**GOVERNMENT OF THE DISTRICT OF COLUMBIA
DEPARTMENT OF TRANSPORTATION**

MEMORANDUM

SUBJECT: Zoning Commission Case No. 13-14B - McMillan Reservoir Parcel 4 Modification

Figure 1 Approved (top) and Proposed (bottom) Site Access and Loading Designs

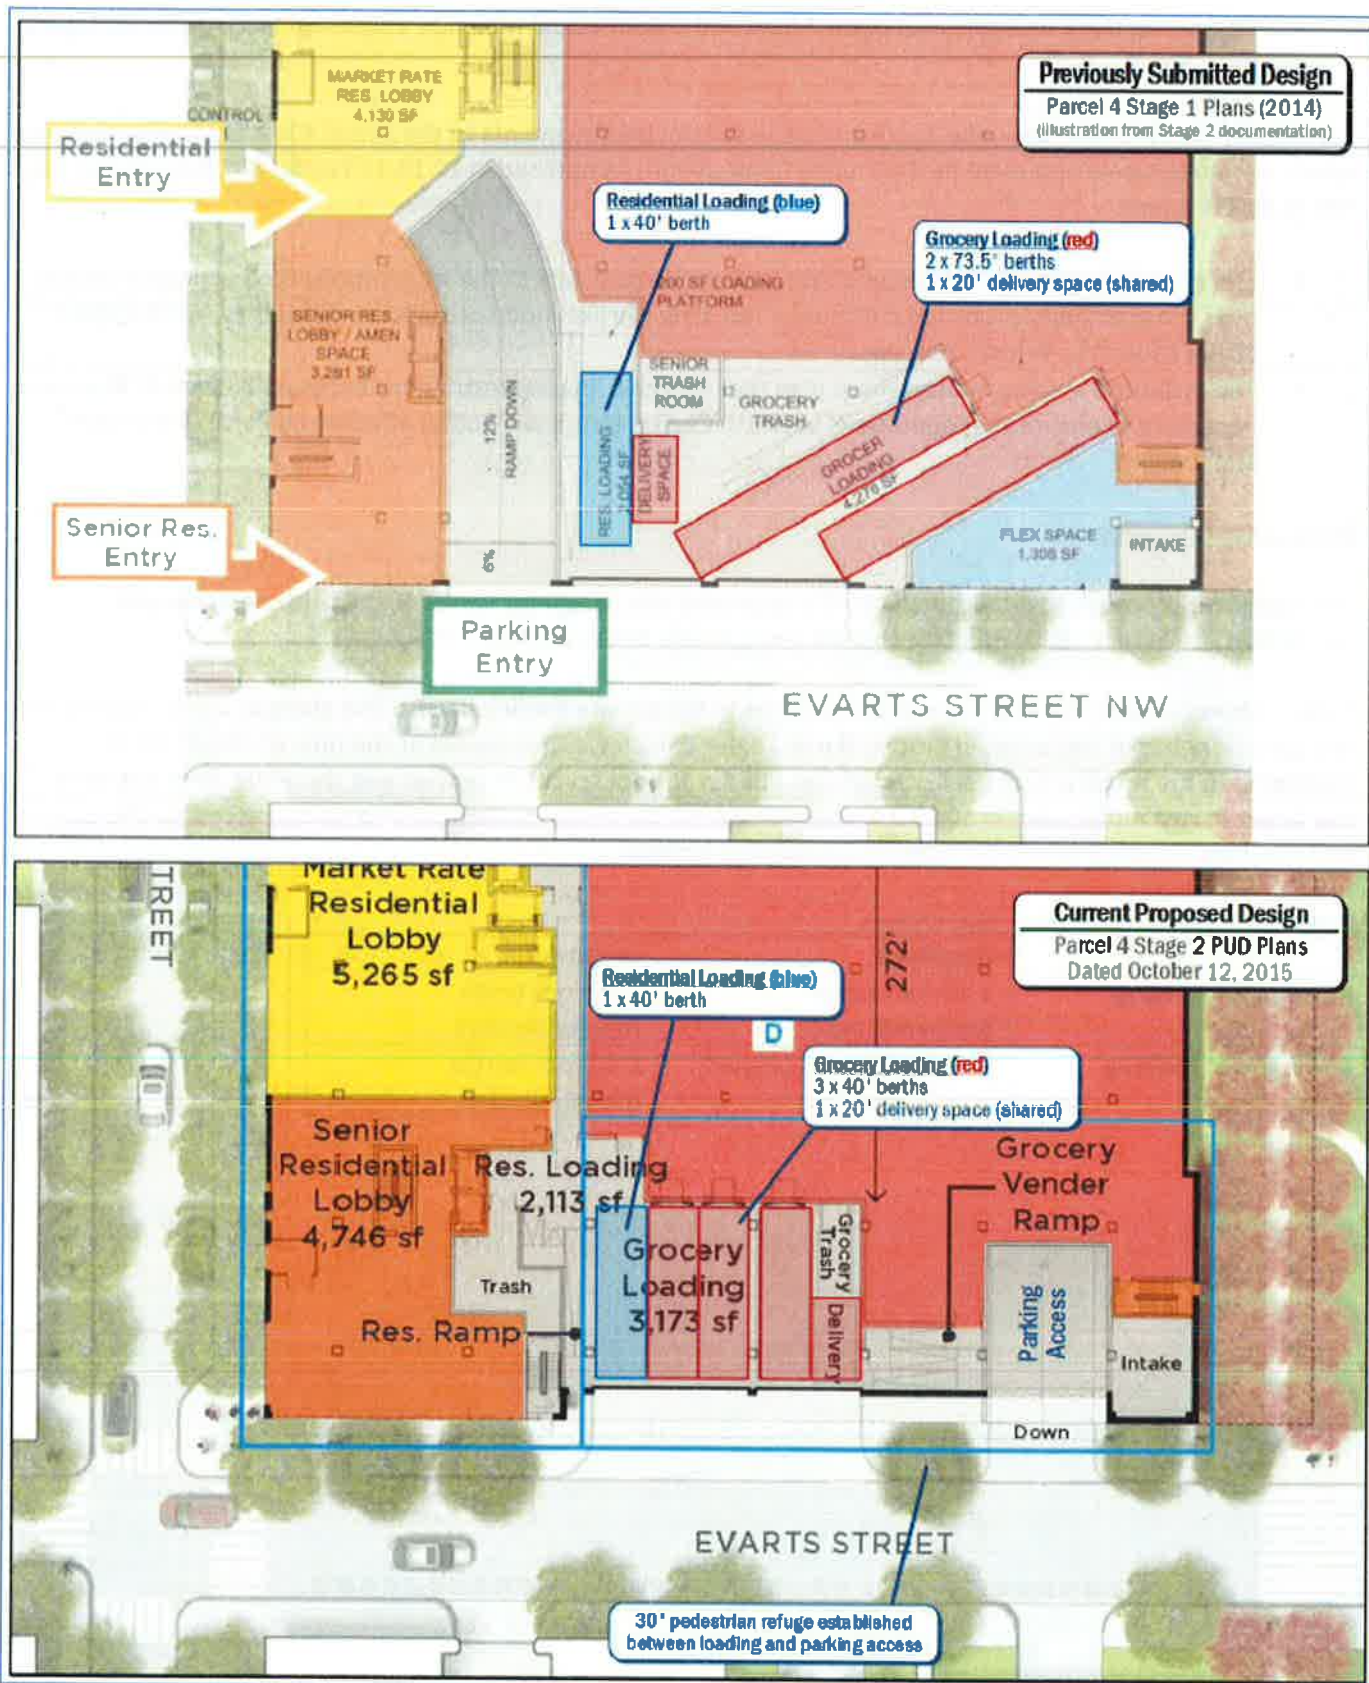
- The requested change in the size and number of loading berths is appropriate for the selected grocer;

- The approved loading facilities require back-in maneuvers, which are inconsistent with DDOT standards, and the proposed reconfigured loading facilities also require back-in maneuvers;

The Applicant proposes several changes to the approved site design for Parcel 4. The proposed changes reorganize site access and loading for the site along Evarts Street as shown in Figure 1.

Table 1 shows a summary of the proposed changes to the on-site loading berths. The changes are in response to the specific needs of the selected grocer, Harris Teeter, which was not known at the time of the ZC 13-14. According to the Applicant, the selected grocer utilizes 40-foot trucks or shorter and therefore does not need the larger berths anticipated in ZC 13-14. The redesigned site design shifted parking garage access to the east and resulted in more but smaller commercial loading facilities.

Figure 2 Proposed Loading Management Plan for Queuing

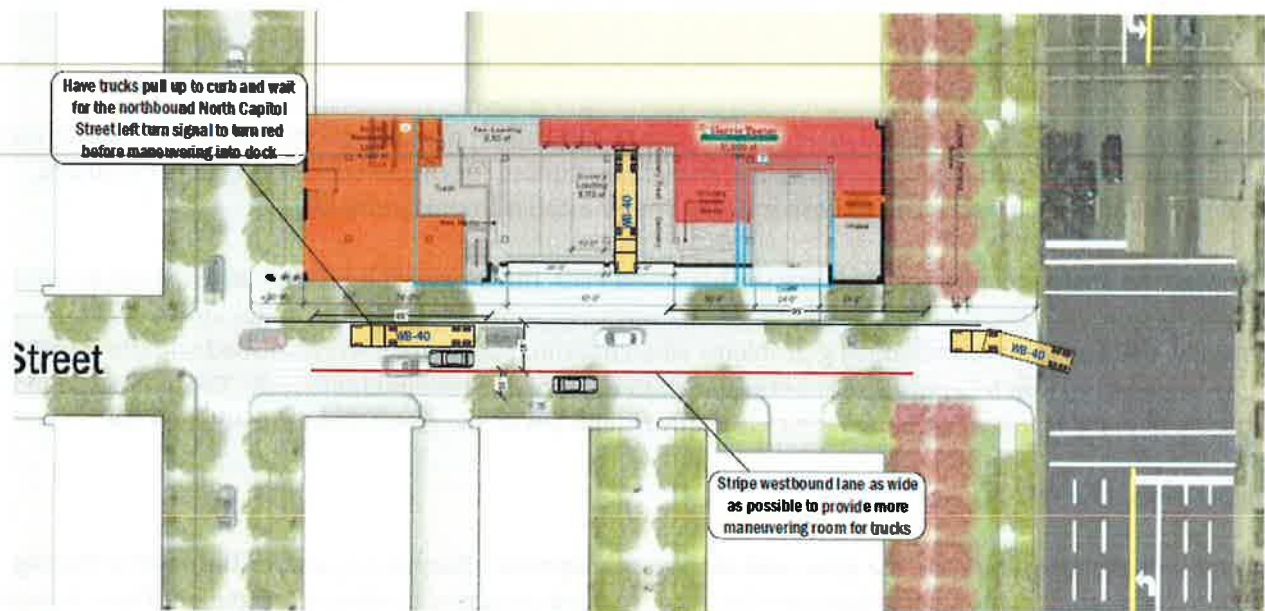
The Applicant seeks to address queuing problems by prohibiting back-in maneuvers to begin when the left turn signal from North Capitol Street is green. To facilitate this measure, the Applicant proposes to design Evarts Street with one travel lane in each direction and a temporary truck parking lane on the north side of the street adjacent to the site where trucks could temporarily park and wait for the loading management coordinator to instruct the truck to proceed once the left turn arrow from North Capitol Street to turn red. The proposal is depicted in Figure 2.

DDOT finds the proposed loading management strategy for managing queuing practically difficult to implement and enforce. The challenges associated with the strategy are described below:

- **Left turn arrow visibility:** The strategy requires that the loading management coordinator be able to see the left turn arrow located on North Capitol Street, which is not visible from the loading dock area. Accordingly, the loading management coordinator would not know when to instruct the trucks to proceed with their back-in maneuver.

- **Curbside space availability:** The strategy is dependent upon keeping the curbside clear and available for trucks to temporarily park. The curbside space is likely to be attractive for vehicle parking. While the curbside could be signed to prohibit parking during times when temporary truck parking is needed, Evarts Street is proposed to be a private street and therefore the District has limited ability to enforce any non-compliance with posted signs. Should a conflict arise, the District cannot be assured that any illegally parked cars can be removed; and

- **Multiple trucks:** Based on DDOT experience with other grocers across the District, simultaneous deliveries by multiple trucks is a common occurrence. Due to the limited amount of curbside temporary parking space, which can only accommodate one 40-foot truck, the viability of the strategy to accommodate multiple simultaneous deliveries is problematic.

Because of the implementation and enforcement issues above, the proposed strategy is highly unlikely to effectively manage vehicle queuing, and queuing on Evarts Street is likely to negatively impact North Capitol Street traffic. The time restriction is needed to manage conflicts between truck activity and vehicular traffic on Evarts Street during the period of the day where potential for negatively impacting operations of North Capitol Street is expected to be highest.

Due to the expected vehicle queueing that will negatively impact traffic operations on North Capitol Street, DDOT objects to the requested modification to remove the prohibition on deliveries between 7:00am-8:30am.
